UNITED STATES PATENT AND TRADEMARK OFFICE

APPLICATION NO.	FILING DATE	FIRST NAMED INVENTOR	ATTORNEY DOCKET NO.	CONFIRMATION NO.
10/676,066	09/30/2003	Philip J. Ireland	2000-0995.01US	7725
7590	09/08/2004			
Kevin D. Martin MS 1-525 8000 S. Federal Way Boise, ID 83706-9632			EXAMINER PHAM, THANHHA S	
			ART UNIT 2813	PAPER NUMBER

Office Action Summary	Application No. 10/676,066	Applicant(s) IRELAND, PHILIP J.	
	Examiner Thanhha Pham	Art Unit 2813

DETAILED ACTION

Figure 14

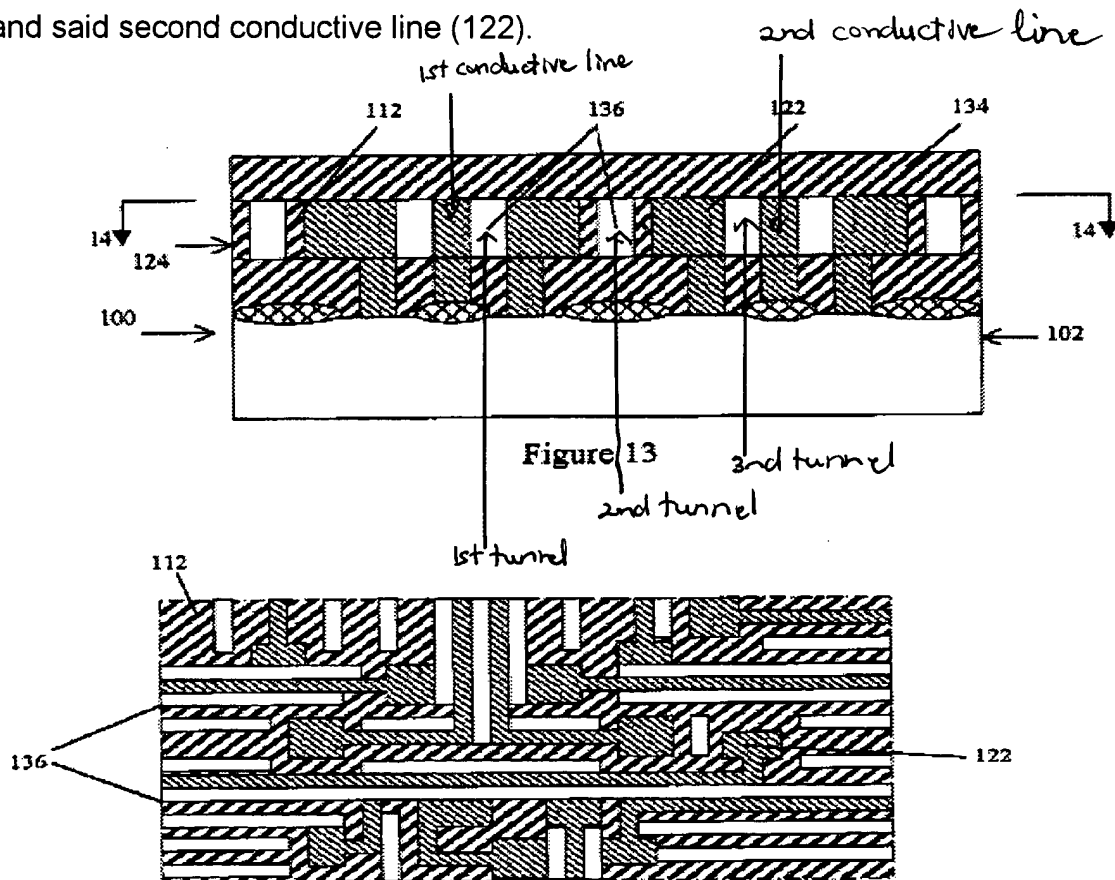
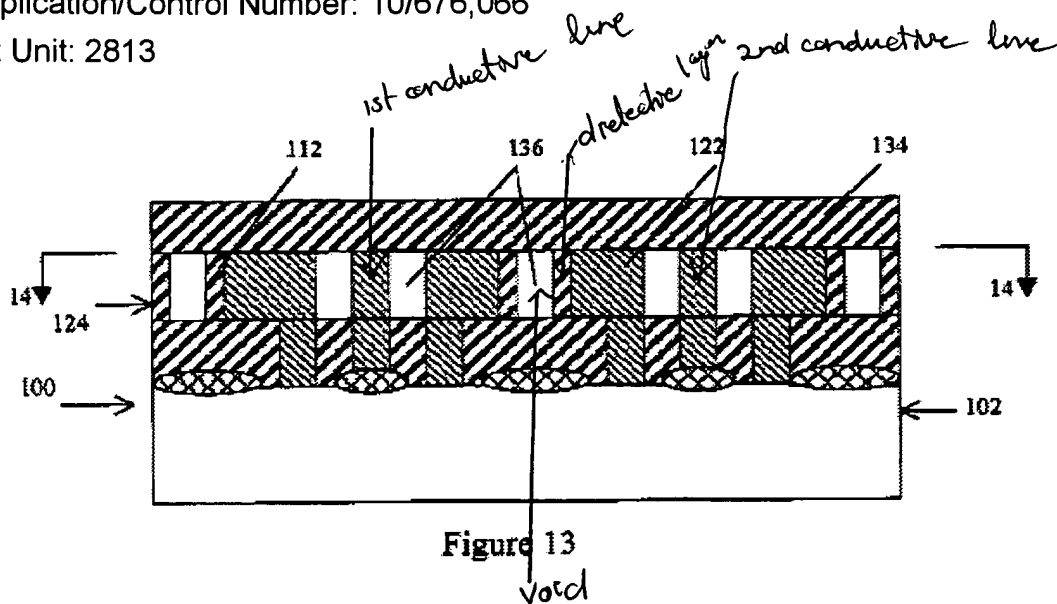
➤ With respect to claim 1, Pang (figs 13 & 14, col 1-13) discloses a semiconductor device comprising:

first and second spaced conductive lines (122, figs 13 & 14, see figure below);

a dielectric layer (112, figs 13 & 14) in a region which extends from said first conductive layer (122) to said second conductive line (122) and is interposed between said first conductive line (12) and said second conductive line (12); and

first, second and third spaced tunnels (136, figs 13-14, see figure below) within said dielectric layer (112) in said region which extends from said first conductive layer to said second conductive line and is interposed between said first conductive line (122) and said second conductive line (122).

- With respect to claim 2, Pang (fig 13) shows that:
 - said second tunnel (136) interposed between said first and third tunnels; and
 - a cross-section area of said second tunnel and a cross-section area of each said conductive line (122), wherein said cross-section area of each said conductive line (122) and said second tunnel are about equal.

- a semiconductor substrate assembly (102, fig 13) comprising a semiconductor wafer section;
 - first and second conductive lines (see figure below) having, in cross section, a width and a height;

- a dielectric layer (112, fig 13) between said first and second conductive lines, said dielectric layer having a void (see figure below) therein, said void comprising a width and a height about the same as said width and said height of said first and second conductive lines.

- With respect to claim 8, Pang (fig 13) shows said void (see figure below) having a generally square or rectangle shape.
- With respect to claim 10, Pang (fig 13) discloses said void (see figure below) being interposed between said first and second conductive lines.
